Appendix 15 - Noise Technical Note

**Applicant Statement of Case - Appendices
CROWN/2025/000002 Sevington Inland Border Facility**

Technical Note – Noise Statement of Matters

Document Reference: 20980119-WAT-ENV-XX-TN-N-710001_C02_A0

Histogram 9: 1/3 Octave Estimated Sound Power Level HGV Idling

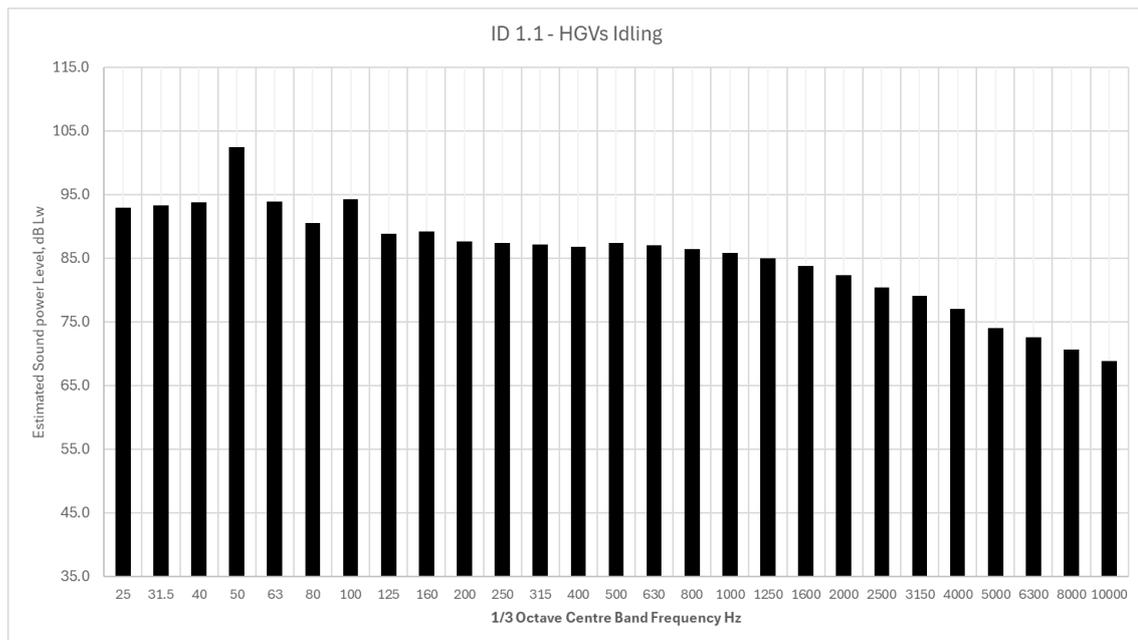
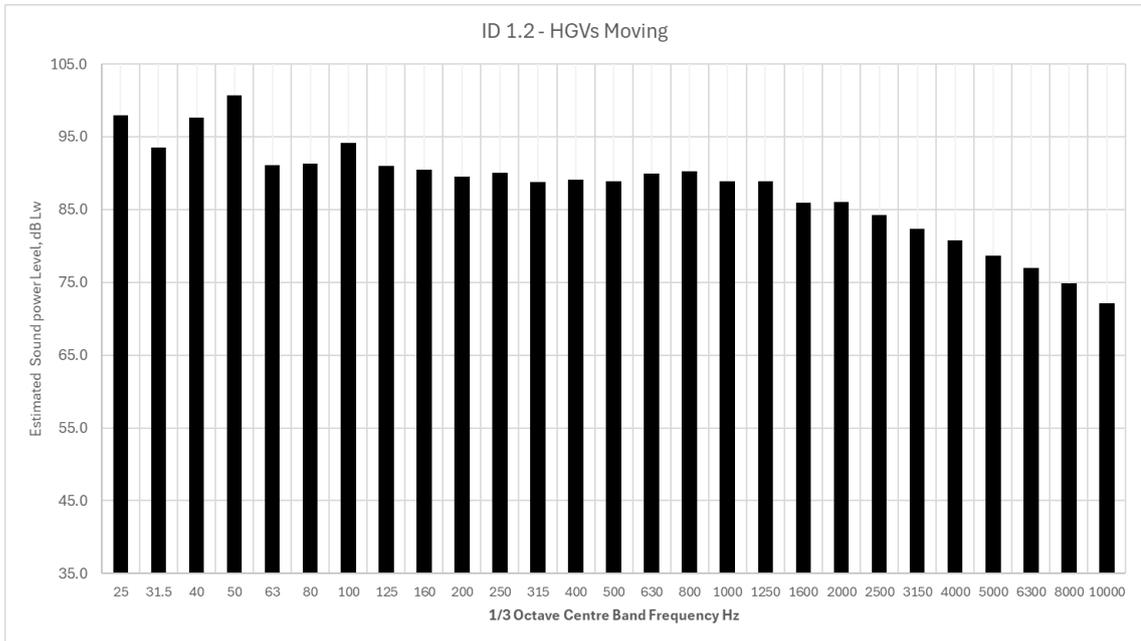
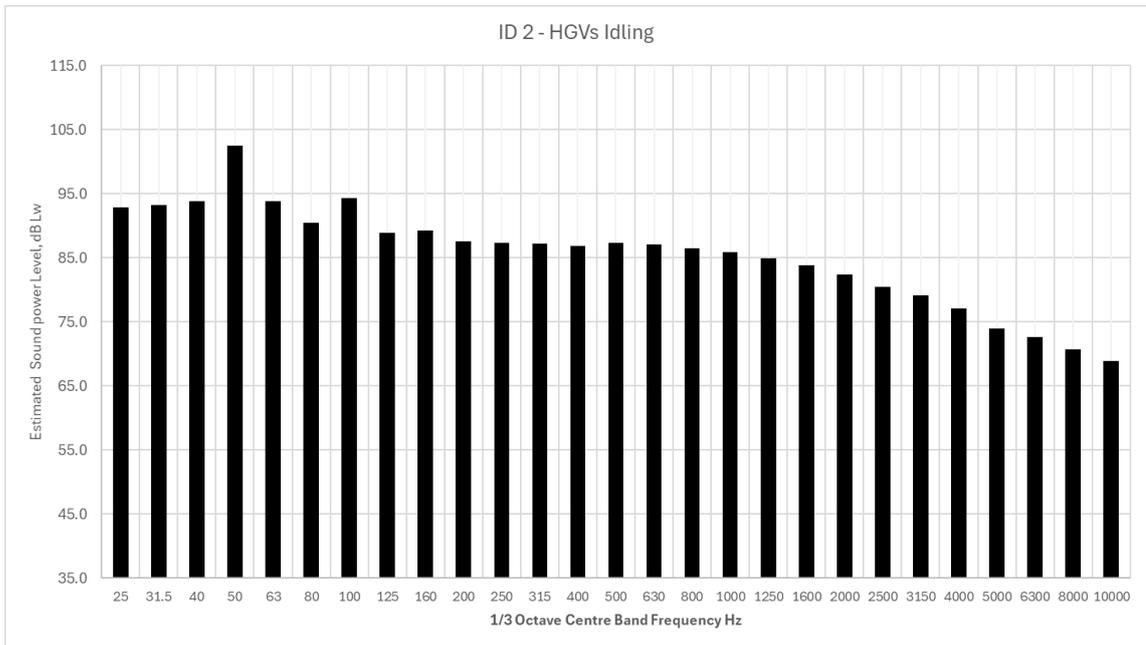
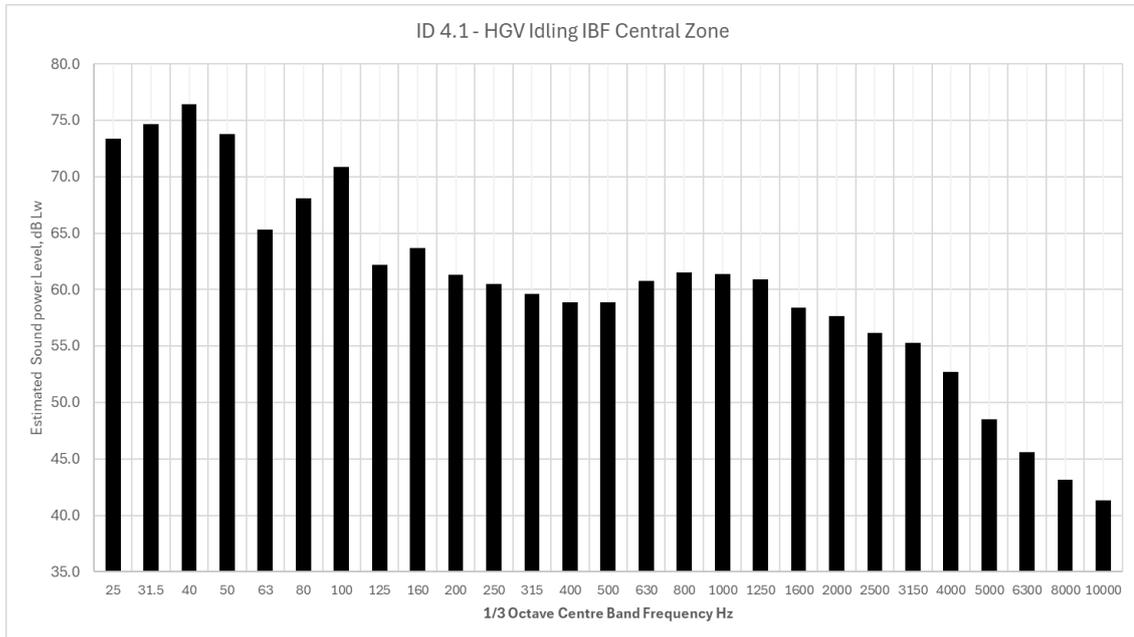
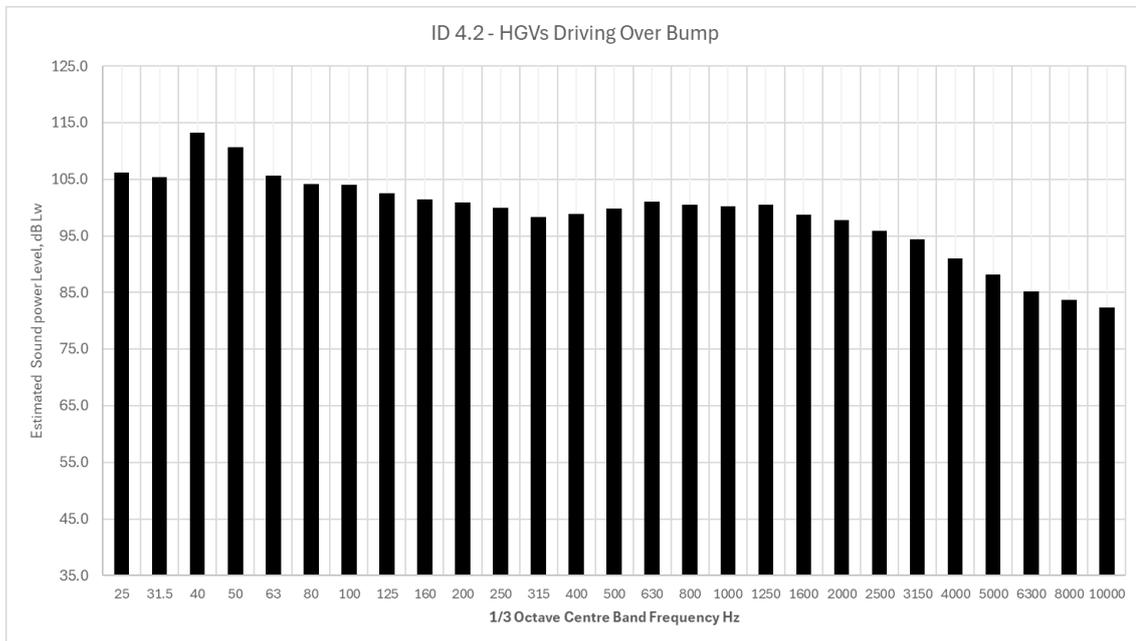
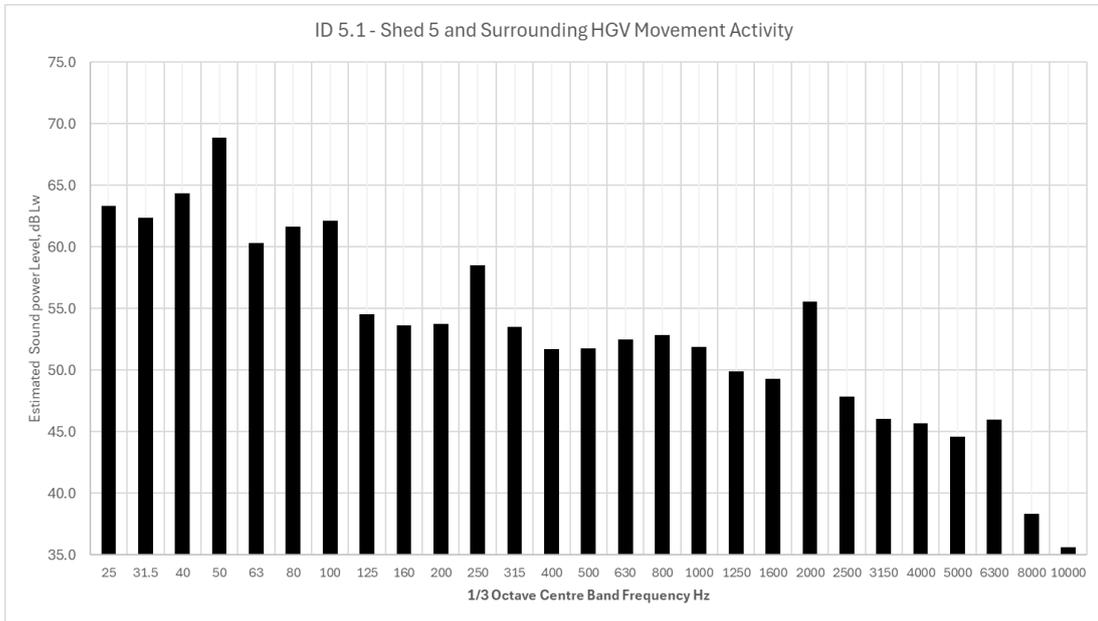
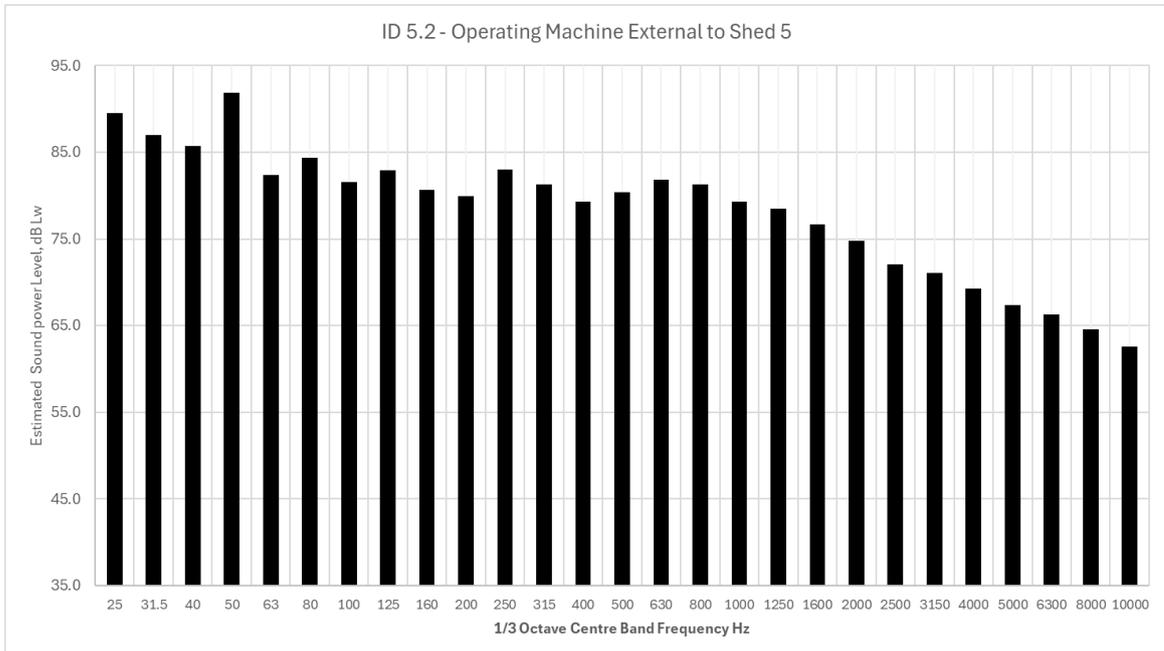
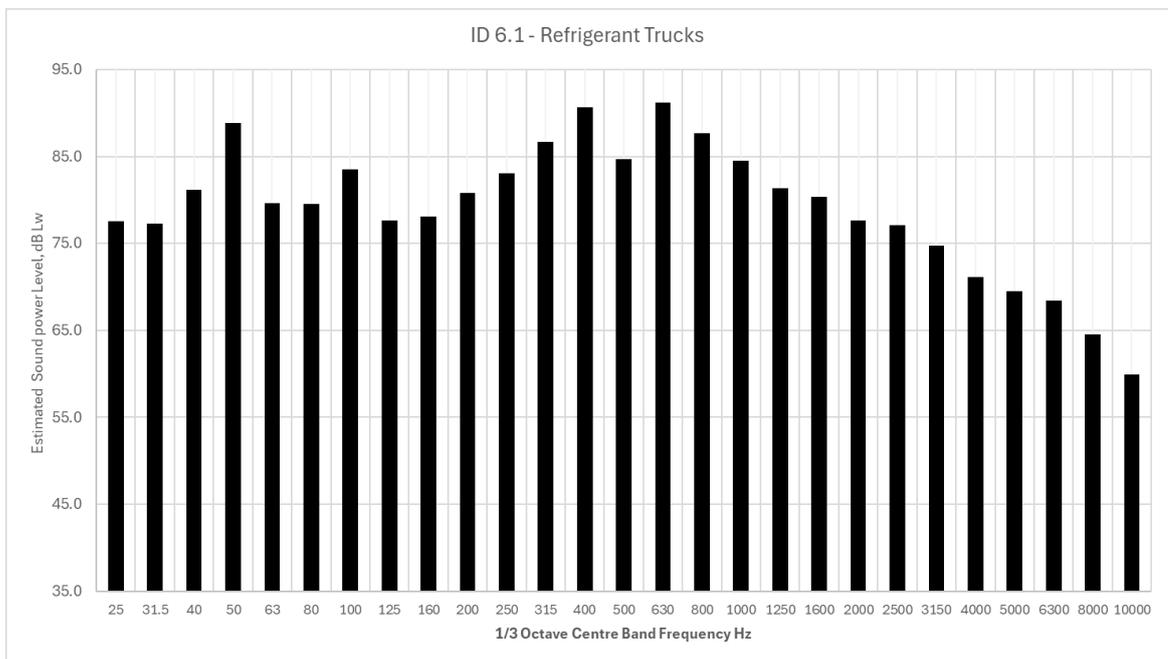
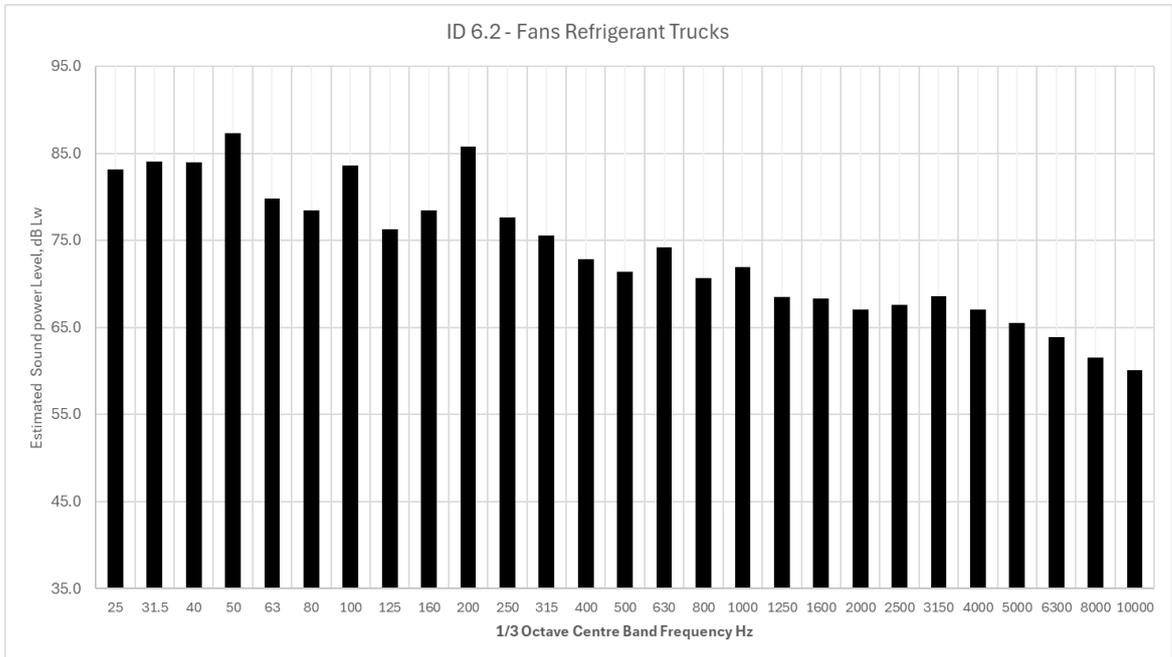
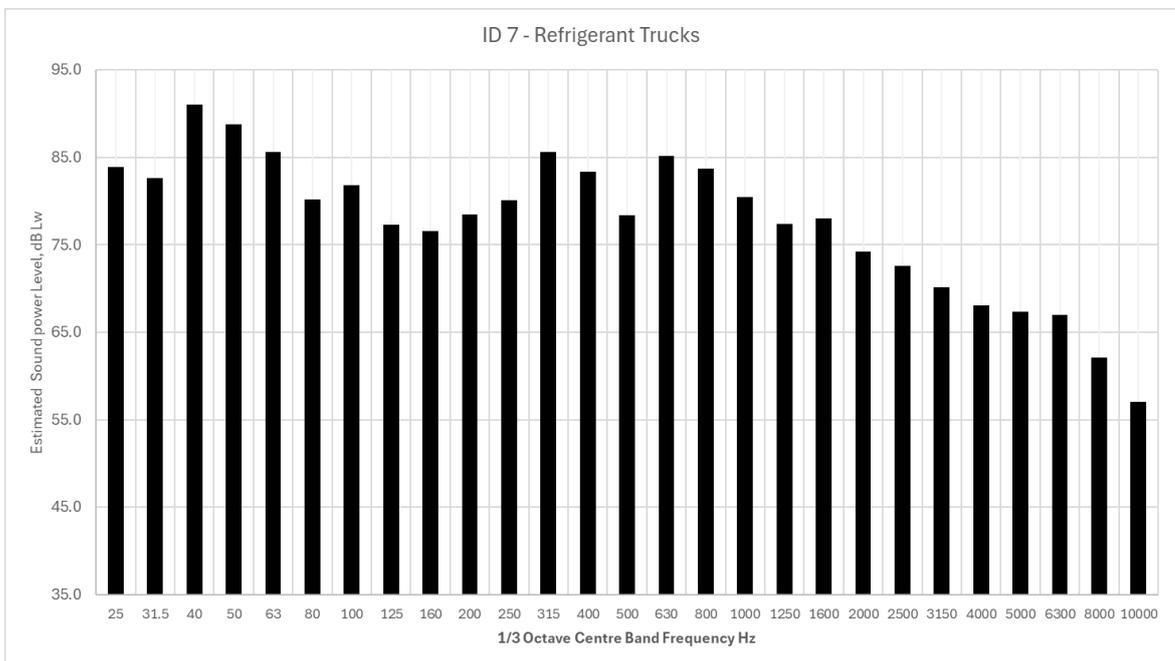
- 9.5. **The concerns raised by the resident [REDACTED] and conduct additional investigation to the reported low frequency noise from HGVs, tonal noise from refrigerated HGV's, reversing beepers, clanging of curtain sider poles and horns in their analysis of the recorded data in their response.**

- 9.19. As detailed in Chapter 9 of the ES and Appendix 9.5, source noise measurements were undertaken of key IBF Sevington noise sources. These were input into the CadnaA noise model to allow prediction of spectrum operational noise levels at the nearest sensitive receptors. As detailed in paragraph 9.37 of the ES, the dominant noise sources was considered to be from the movement of HGVs around the Site.
- 9.20. Histogram 5 to Histogram 14 present the 1/3 octave sound power levels derived from measurement of the various IBF noise sources. It should be borne in mind that the acoustic spectrum of the sound at source is not necessarily reflective of the acoustic spectrum at receptor locations, due to distance attenuation and intervening screening. It is the acoustic character at receptor location that is used for the BS4142 assessment and not the noise spectrum at source

- 9.21. *HGV idling appears to have a prominent tone at 50Hz (refer to Histograms 5 and 7). Based on the level difference with the adjacent 1/3 octave bands it would not normally be regarded as tonal. Conversely the HGV bypass event does not exhibit any prominent tones (refer to Histogram 6).*
- 9.22. *Histogram 8 represents the spatial average of HGV idling in the IBF Central Zone. The spectrum exhibits a higher low frequency content compared to the mid to high frequencies, but with no dominant tones evident. HGVs arriving and leaving the area as well as reverse alarms also contributed to the spatial measured noise levels. It should be noted that the estimated spatial average sound power level within the lower frequencies are significantly lower than illustrated in Histograms 5, 6 and 7.*

- 9.23. *Histogram 9 has slight elevation at 40Hz and 50Hz but not considered to be prominent enough to be tonal.*
- 9.24. *Histogram 10 indicates an elevation at 50 Hz and 250Hz, but based on adjacent 1/3 octave band wouldn't normally be considered as tonal. There is potentially some tonality at 2kHz, however when account is taken of the absolute level and distance separation to the nearest residential properties and intervening screening, these would be reduced to below residual noise levels at receptor locations. For example, a sound power level of 56dB Leq at 2kHz, would reduce to approximately 4dB Leq based on 20 log attenuation and 26dB Leq based on 10 log attenuation.*

9.25. *Histogram 11 indicate an elevated level at 50Hz, but as previously stated, the level difference with the adjacent 1/3 octave bands is not normally regarded as tonal within this part of the low frequency spectrum.*

9.26. *Histogram 12 indicates an elevated level at 50Hz but with some elevation in the mid to high frequency at 400Hz and 630Hz. Taking account of refrigeration truck hook up locations within the IBF site, Defra central and HMRC east of 'Romeo' emergency parking area, they are considered to be too distant from residential receptors to result in discernible noise levels. The Defra central area hook up is approximately 345m from nearest Church Road residential properties and HMRC hook up is approximately 375m from the nearest Church Road residential properties.*

9.27. *Histogram 13 indicates elevation in levels at 50Hz, 100Hz and 200Hz resultant from fan noise associated with the refrigerant truck. Fan noise at 50Hz, 100Hz, and 200Hz is caused by a combination of aerodynamic (turbulence and blade passing) and mechanical issues. The 50Hz noise is likely from the AC power supply, while the 100Hz and 200Hz sounds are related to the fan's rotation speed, often referred to as the "blade pass frequency".*

9.28. *Histogram 14 indicates elevation in level at 40Hz from the refrigerant truck, although based on the 1/3 octave spectrum it is not evidently regarded as tonal.*
